April 2022 Solicitation Questions and Responses

FLOOR PLAN

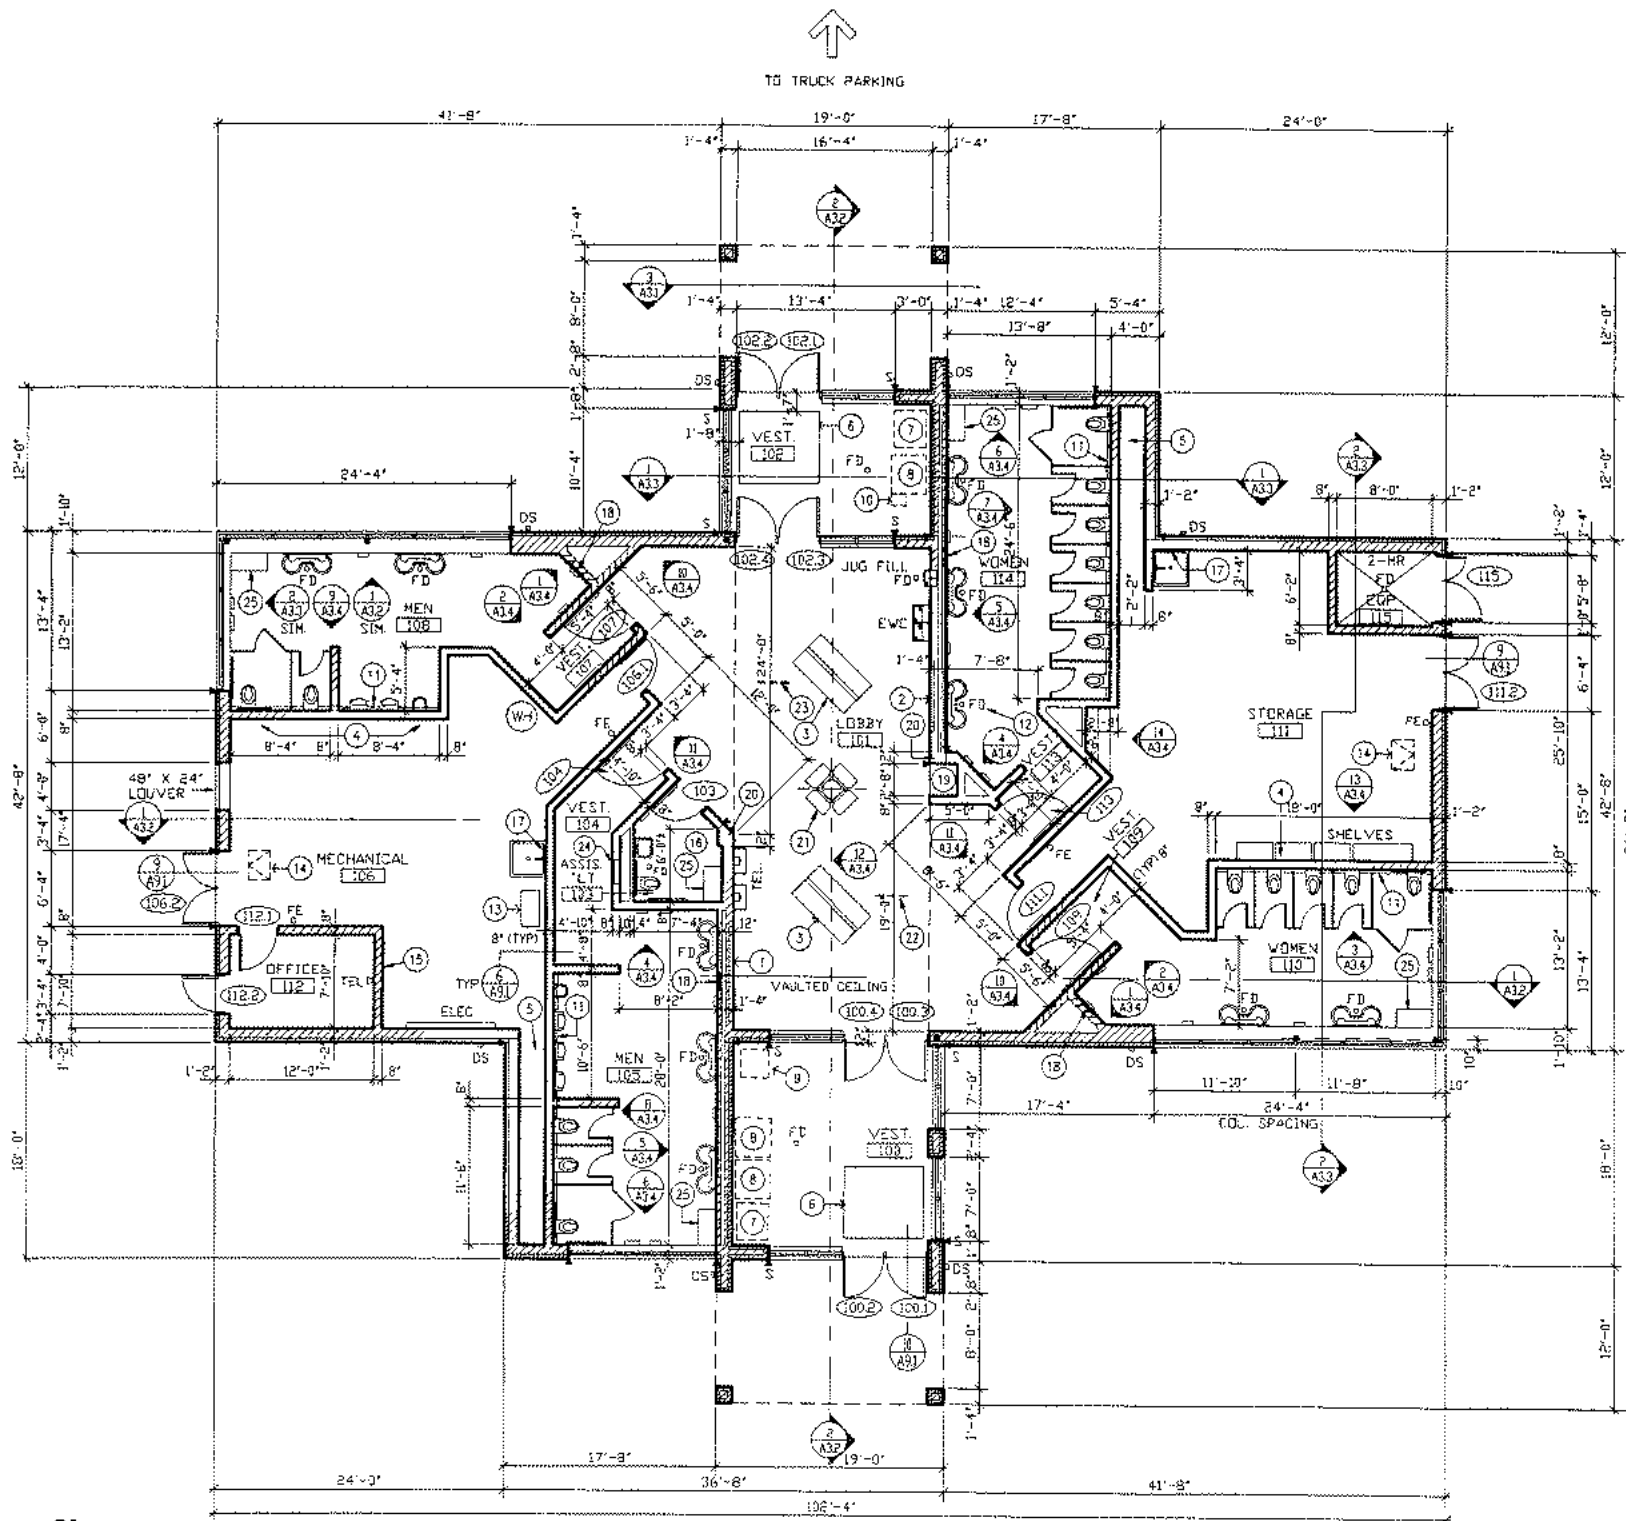
Solicitation	Project	Question	Response
BHM-01	1071-07-09	What are the main desired features of the facility?	2 family assisted bathrooms, 2 men's bathrooms, 2 women's bathrooms, maximized CMV truck parking. The site plan and plan view of Rest Area 14 Johnson Creek, I-94 westbound, Jefferson County (attached) are anticipated to be similar to the new design.
BHM-02	1225-10-02	What are the main desired features of the facility?	2 family assisted bathrooms, 2 men's bathrooms, 2 women's bathrooms, maximized CMV truck parking. The site plan and plan view of Rest Area 14 Johnson Creek, I-94 westbound, Jefferson County (attached) are anticipated to be similar to the new design.
NE-01	4115-14-00, 4115-15-00	Is structure work anticipated?	There will be an overlay on one structure and miscellaneous secondary work.
NE-01	4115-14-00, 4115-15-00	What are the drainage improvements (culvert replacements or other)?	Most culverts will be replaced.
